06-WTP-109

CONTRACT NO. DE-AC27-01RV14136 - TRANSMITTAL OF U. S. DEPARTMENT OF ENERGY, OFFICE OF RIVER PROTECTION (ORP) DESIGN OVERSIGHT REPORT: "HYDROGEN IN PIPING AND ANCILLARY VESSELS (HPAV) GENERIC SOLUTIONS" (D-06-DESIGN-023)

**HYDROGEN IN PIPING AND ANCILLARY VESSELS
(HPAV)
GENERIC SOLUTIONS
DESIGN OVERSIGHT REPORT
D-06-DESIGN-023**

APPLICATION OF BLOCK AND BLEED CONFIGURATION

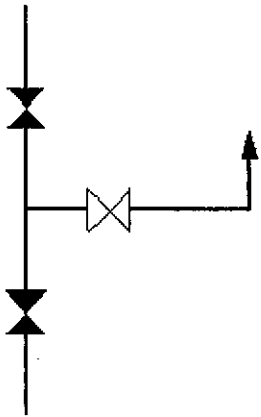
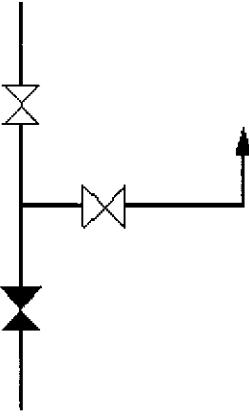
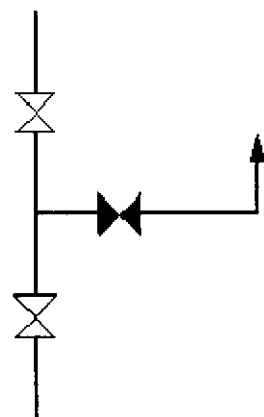
The Design Oversight Team questioned the design of the air purge system for the UFP. Specifically, the PSA system purge air to UFP is controlled through the use of plug valves. In the higher pressure sections of the UFP system, it appeared to the Design Oversight Team that leakage through the plug valves or the inadvertent opening of a plug valve during normal operations, particularly on the loss of the PSA system, could result in contamination of the PSA system. The Design Oversight Team questioned BNI as to the design or other features that prevent this possible contamination event that could affect large portions of WTP. BNI responded that the PSA air supply is backed up by the ITS air supply and both air system pressures are significantly higher than the UFP pressure at the PSA/UFP interface. In addition, the design includes two normally closed isolation valves between the PSA/ITS air supply systems and the UFP system.

As discussed above, the Design Oversight Team questioned the design of the purge air supply to the UFP system (see Open Item No. 1). During discussions with BNI personnel, it was identified that the design of the purge air supply to the mid-section of the UFP loop involved a single (i.e., not redundant) purge air supply line. Although BNI concluded that a potential detonation in this part of the UFP system was not a safety issue, such a detonation could impact the availability of this PTF process system. In this regard, the Design Oversight Team identified Open Item No. 10.

Configuration 1 – Normal operation; cross connected systems are isolated from each other; cross connect vented.

Configuration 2 – Prepare to purge; high pressure side opens to clear vent and cross connect from any leakage.

Configuration 3 – Vent closed; systems cross-connected.

Figure A-1. WTP Plug Valve Redesigned to Eliminate Dead Leg

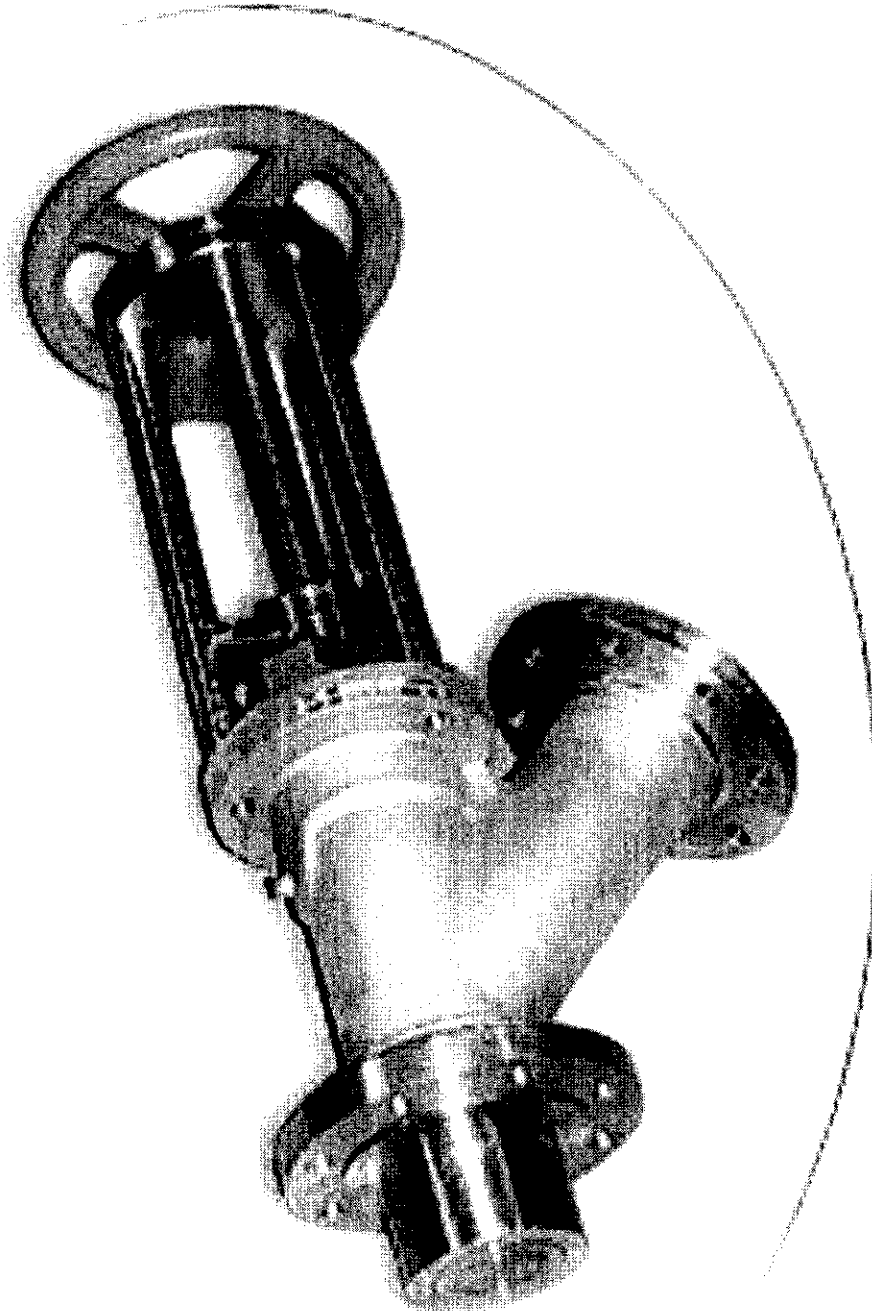
No.	Question	Comment	Response ¹	Status
9	Provide description of new valve that replaced deleted spare suction lines (Page 7, Presentation of 6/5/06 – Plant Availability Assessment of PTF and HLW, Ed Strieper)		A picture of this valve was provided to the Design Oversight Team by BNI on 6/9/06 (see Figure A-1). The valve has an extended plug that eliminates the dead leg when the valve is closed. It replaces the cell suction line valves (also see item no. 37).	CLOSED
10	Clarify the variations in approaches taken to address HPAV as a function of the time frame in which an excessive hydrogen accumulation is calculated to occur and the effect of these actions on procedural controls and operator actions.	This was covered briefly in pages 7 and 8 of the Plant Availability Assessment of PTF and HLW by Ed Strieper, 6/5/06. The relationship between the times to grow a bubble, (e.g., < 50 hours, >50 hours, 1000 hours, a year) and the corrective actions is not clearly understood.	<p>tBOC = time to grow a bubble to the piping elastic limit using the BOC calculation</p> <p>If tBOC > 8760 hours, no action is taken</p> <p>If 96 hours < tBOC < 1000 hours and this is a safety case and the strain during detonation > 15% (old criteria), action is required (usually a design feature (e.g., sloped pipe to vent to a lower pressure) or administrative control (e.g., pipe purge or flush))</p> <p>If 50 hours < tBOC < 96 hours and it is a safety case and strain is > 15% (old criteria), operator action cannot be used to preclude detonation; other action (e.g., design feature or engineering solution) is required.</p> <p>If tBOC < 50 hours, this is considered an availability issue and an engineering solution is required to preclude the detonation (whether a safety case or not)</p> <p>Review of the piping matrix shows times of 3000 hours and 1000 hours, but not 8760 hours. What is the variation in actions for these several different criteria? This question was closed in meetings with R. Garrett and E. Strieper on 6/12/06 and 6/13/06.</p>	CLOSED

No.	Question	Comment	Response ¹	Status
37	Redlined note 29 on drawing 24590-PTF-M6-HLP-00001 states that a valve will be added that seals flush against the suction pipe. Provide details of valve type and installation details.		A picture of the plug valve was provided (see Figure A-1). The valve has an extended plug that eliminates the dead leg when the valve is closed.	CLOSED
38	In the piping matrix comments/open issues column, many entries state "Jumpers are assumed to be as strong as the adjacent piping". What is the basis for this statement?	Piping is not the most limiting element of the assembly. Gaskets, seals, bolting, etc must be considered.	BNI based the assertion that the jumpers are as strong as the piping in which they are located on the fact that the piping and jumper have the same schedule. In addition, BNI was only concerned about the bulk confinement of the waste (e.g., at the seal joint). BNI stated that only bulk confinement is required. Small leakage from seals and gaskets was considered in the spray leak DBE analysis.	CLOSED
